MEETING MINUTES

Johnson County Joint Emergency Communication Center (JECC) Subcommittee

Meeting Date: April 18, 2008

6. Building Design

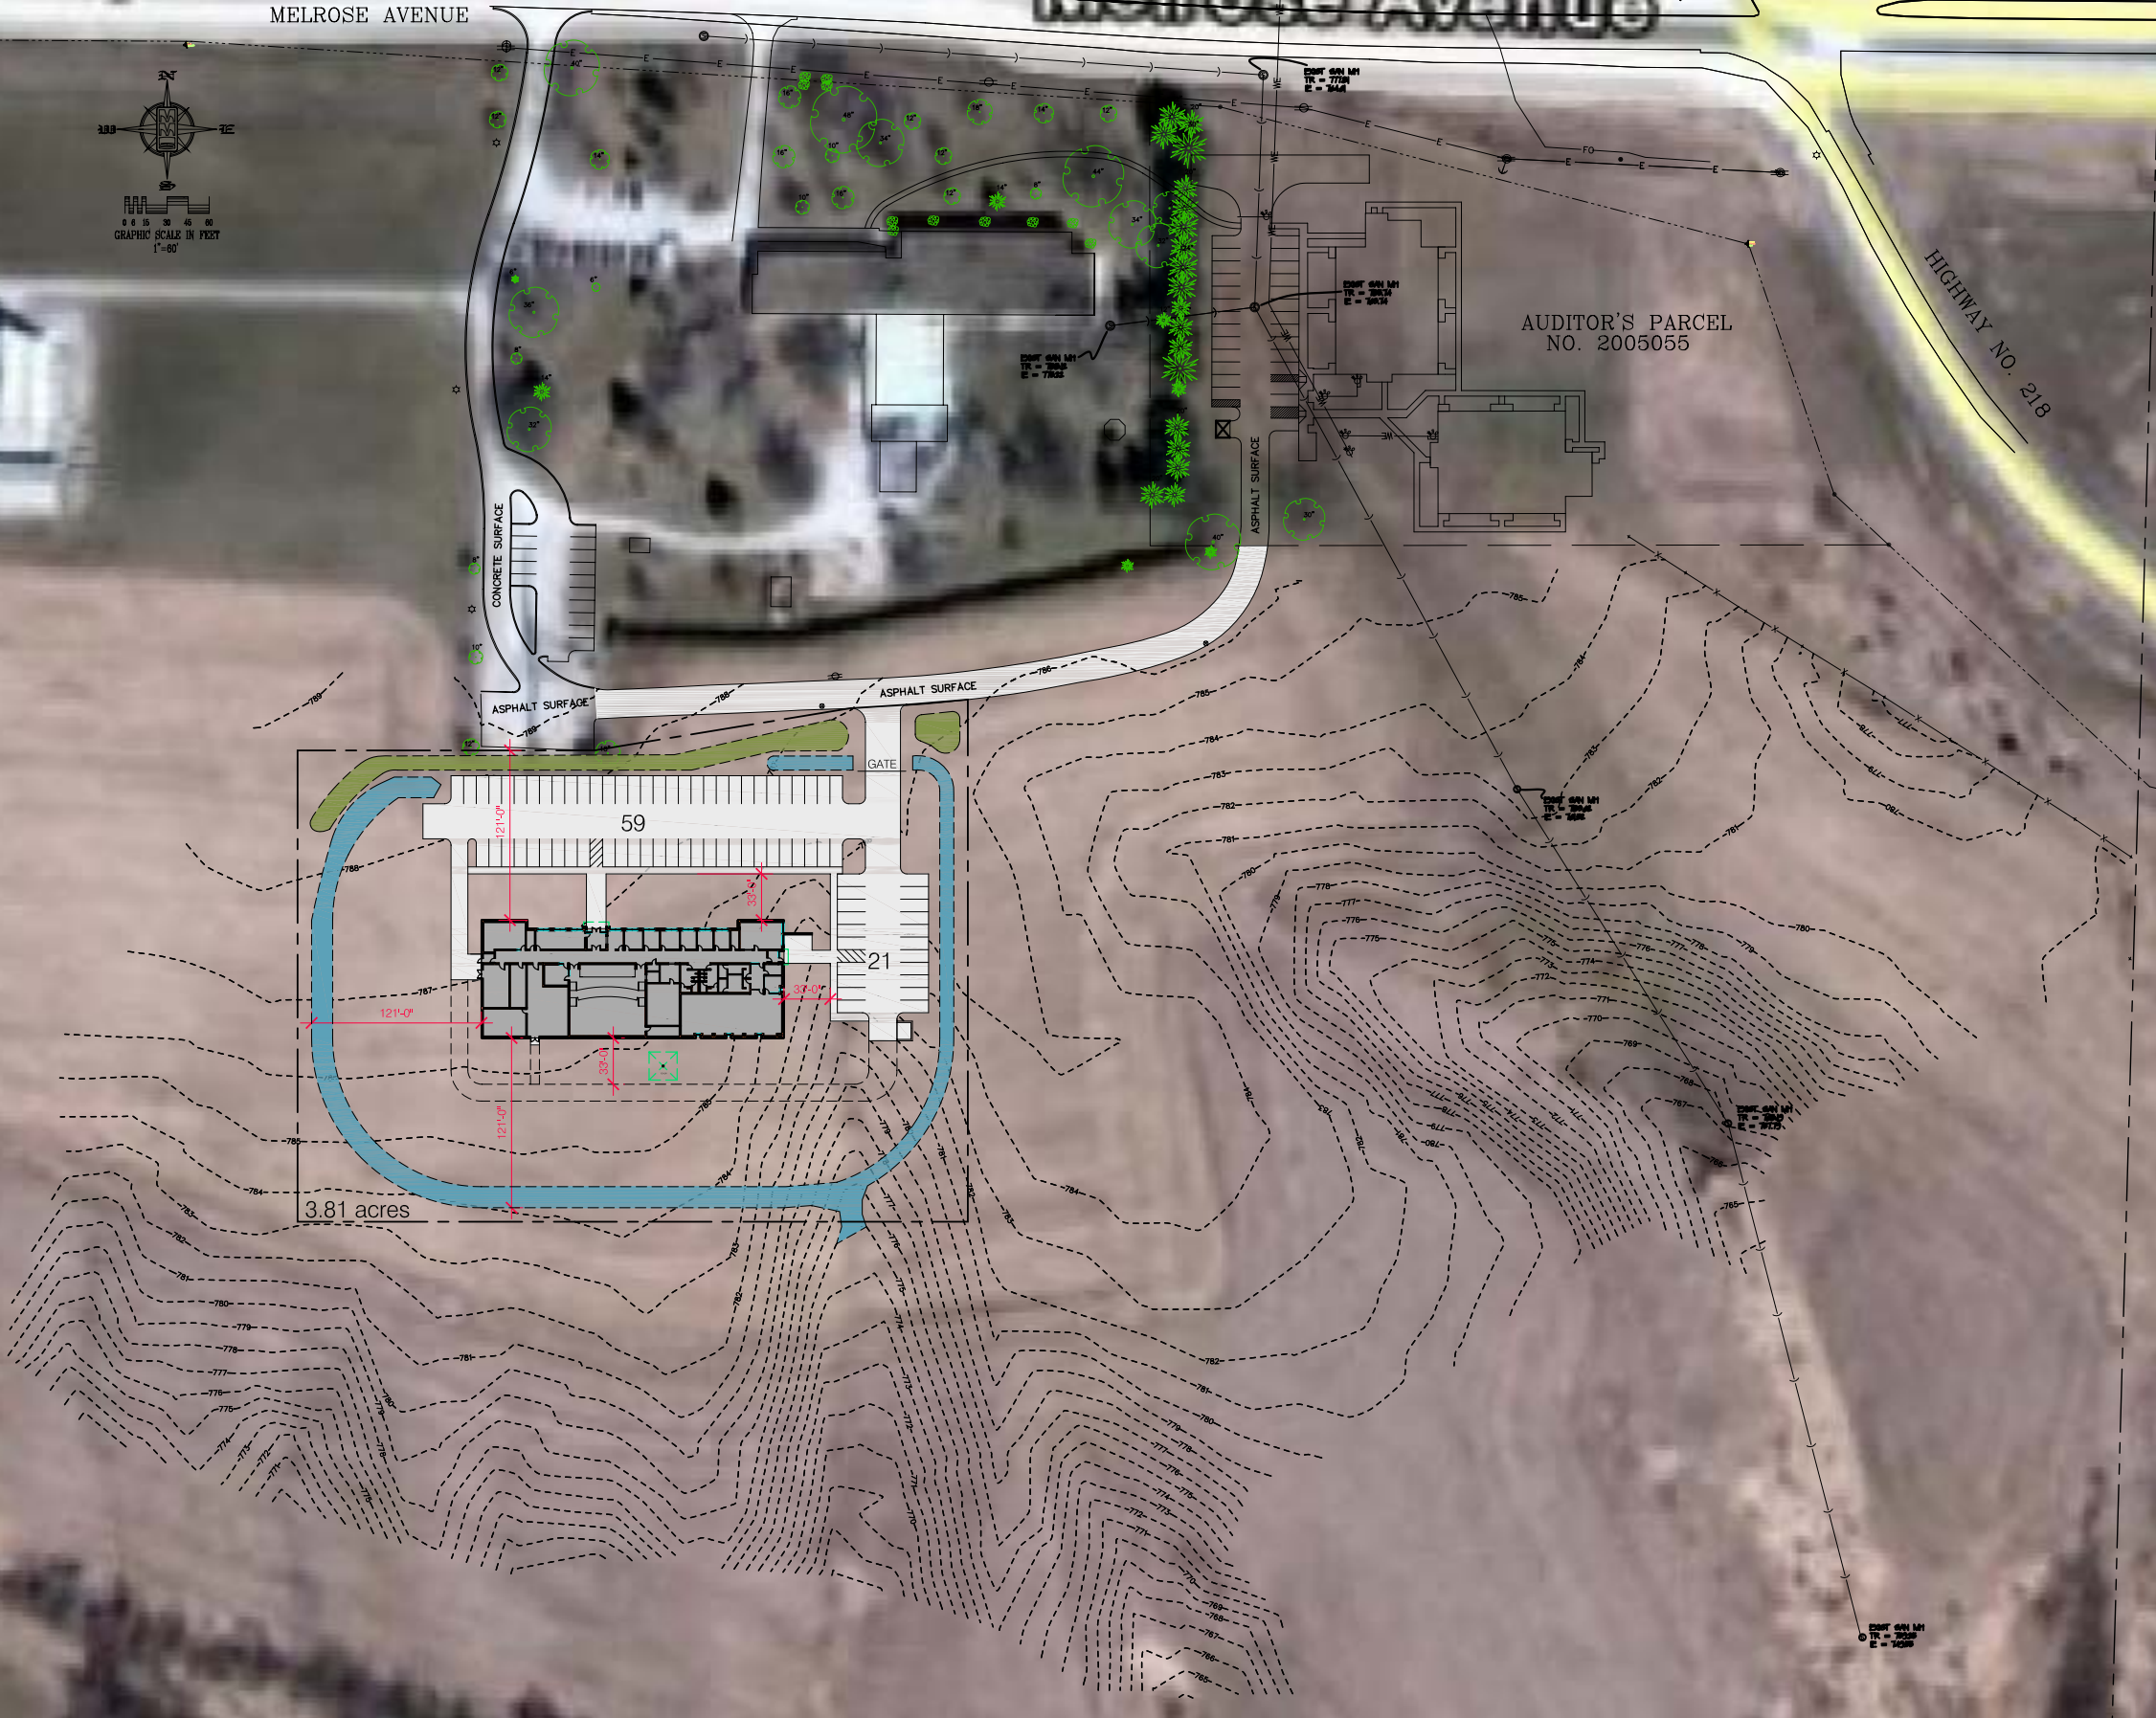
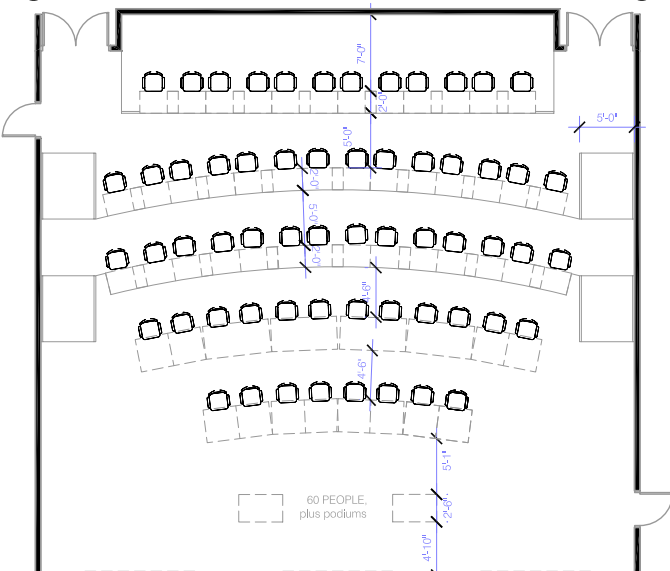
- ii. Site:
 1. The subcommittee would like to get rid of the Chatham Oaks parking on the south side of the Melrose Ridge access drive. If that cannot be done, then the JECC parking lot and building needs to shift south to allow more space for the berm between the lots. The County shall pursue eliminating the Chatham Oaks parking.

2. NM will work with MMS to prepare a legal description of the property for leasing. They will factor in potential grading easements and construction setup limits.

3. The site is currently leased to a farmer. The County shall notify him of the project and alter his lease.
 4. The west, south, and east perimeter may be reduced to 100 feet.

SCHEMATIC FLOOR PLAN

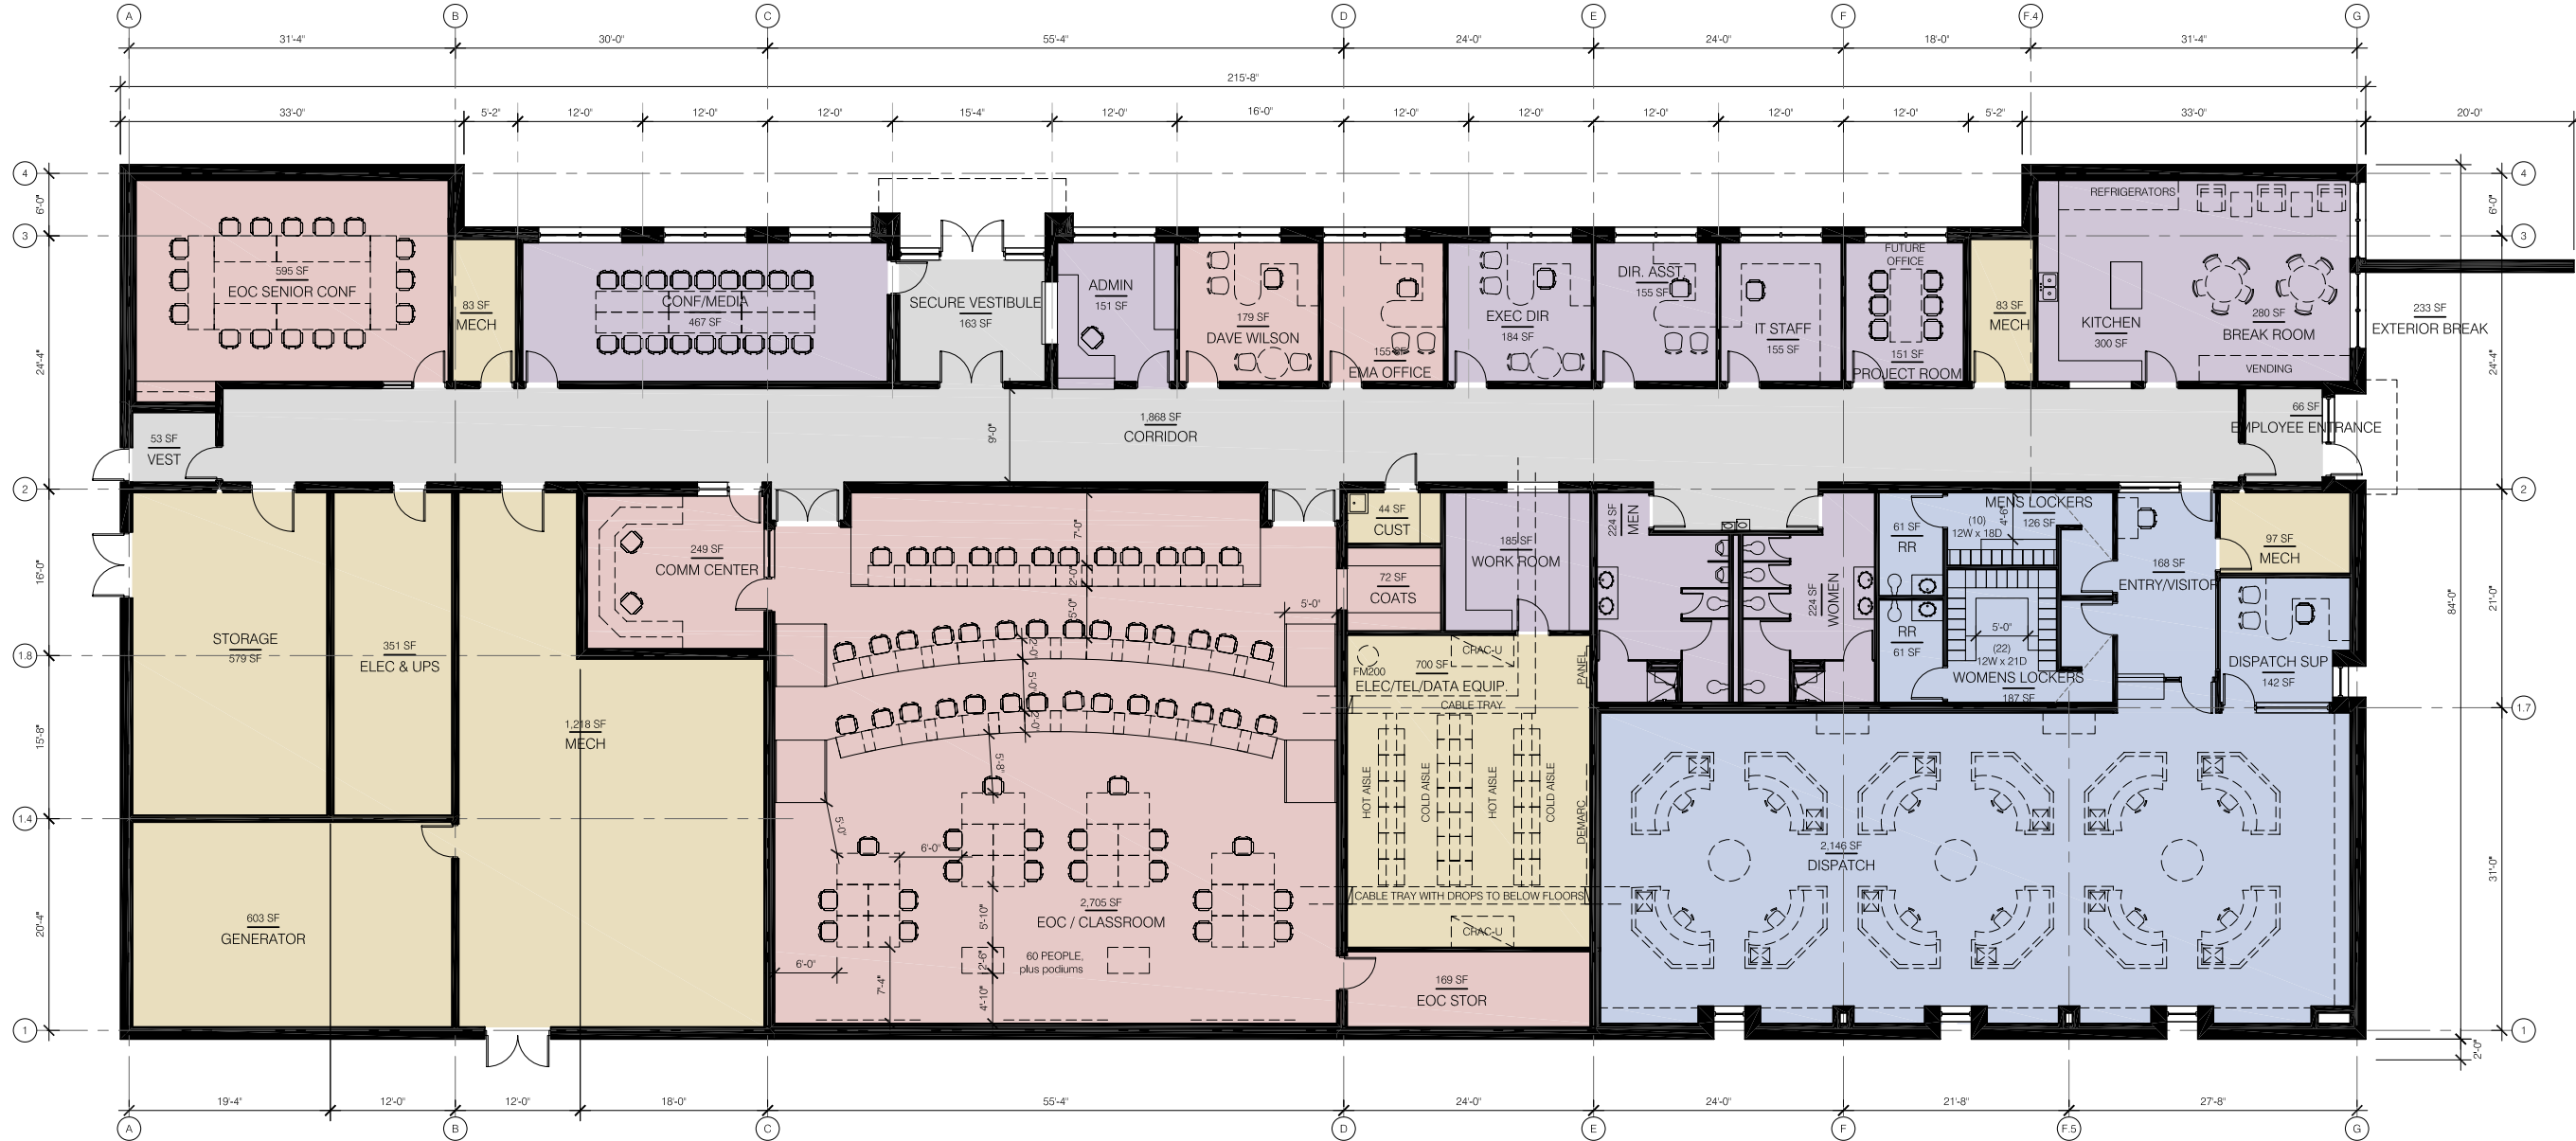
- iii. General Building items:
 1. The facility cannot have any roof problems.
 - a. The roof construction will be structural precast with a ¼" per foot sloped topping slab, insulation, waterproof membrane, and protective concrete topping slab. The goal is no roof penetrations except roof drains.

- b. NM will investigate the cost of raising the entire building to one height to eliminate flashing issues at roof-wall intersections.
 - c. Both CRAC-Units in the Data Equipment Room will be located at the north end of the room, so that all three rack aisles can expand to the south if necessary.
